18-074ARB-MPR – SCHMITT RESIDENCE

Proposal

Construction of a 720-square-foot building addition, covered porch, exterior modifications, and associated site improvements.

18-074ARB-MPR
Minor Project Review
109 S. Riverview Addition

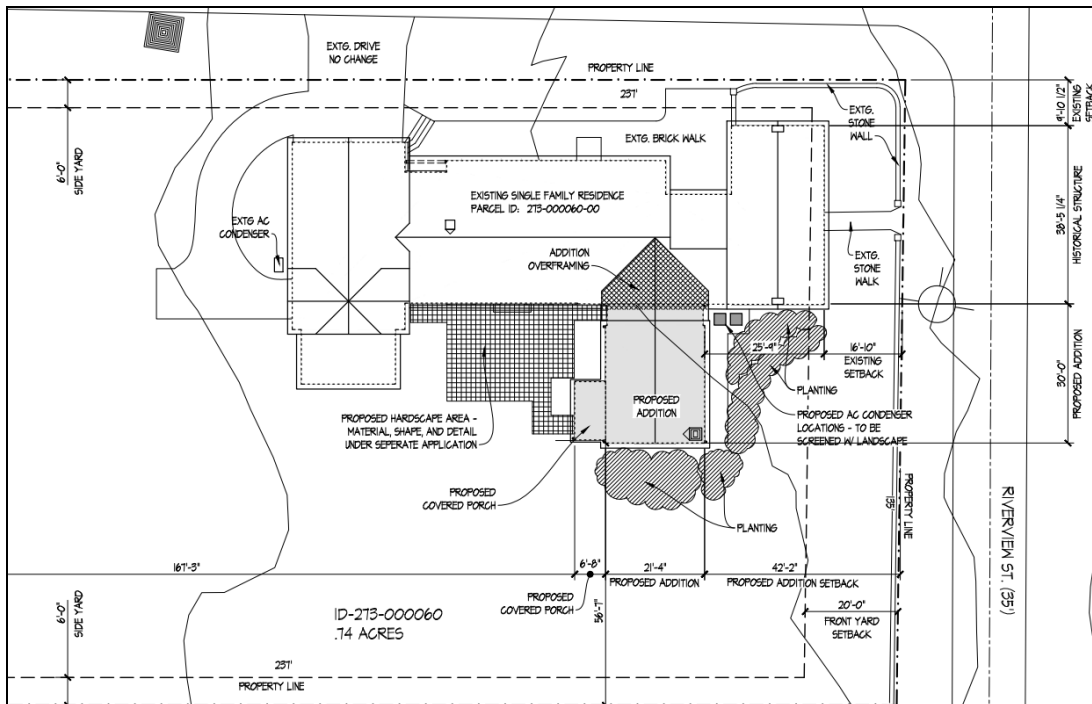
The applicant is also proposing an approximately 700-square-foot at-grade patio, which will be centrally located on the south side of the home between the proposed addition and previous garage addition. The final design should be subject to Planning approval

provided the approximate size and location remain the same, and all zoning requirements are met.

4. Architecture
S. Riverview (East)

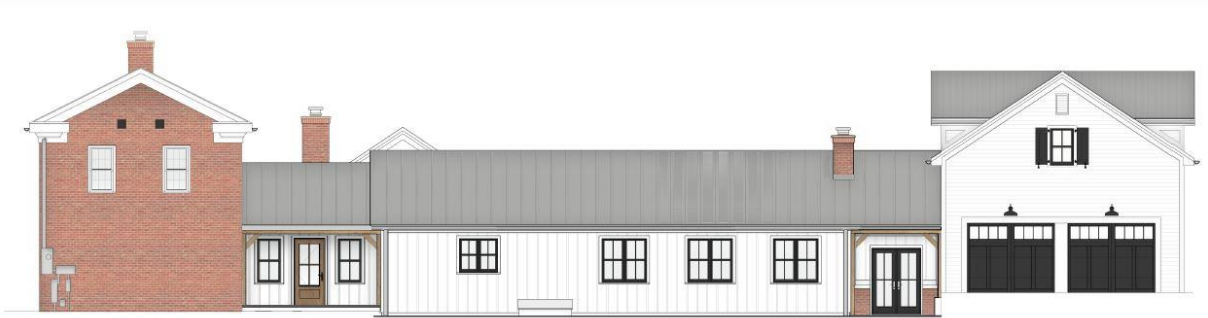
The applicant is proposing a chimney along the S. Riverview Street elevation. Staff and ART raised concerns that the size of the chimney is not comparable with the chimneys on the historic structure and the previous additions. The applicant has indicated the dimensions of the chimney are limited by Building Code requirements. ART recommends the applicant investigate a design solution to reduce the size of the proposed chimney.

- 4) **Alteration recognizes historic integrity and appropriateness.**
Criteria Met with Condition. Staff recommends the applicant reduce the size of the proposed chimney and be more compatible in size to the chimneys on the home, particularly given with the prominence of the proposed chimney location.

- 1) That the applicant reduce the size and scale of the chimney on the proposed addition; and,
- 2) That the final details associated with the at-grade patio be approvable by Planning through issuance of a Certificate of Zoning Plan Approval provided the design be deemed appropriate, and the general size and location do not change.
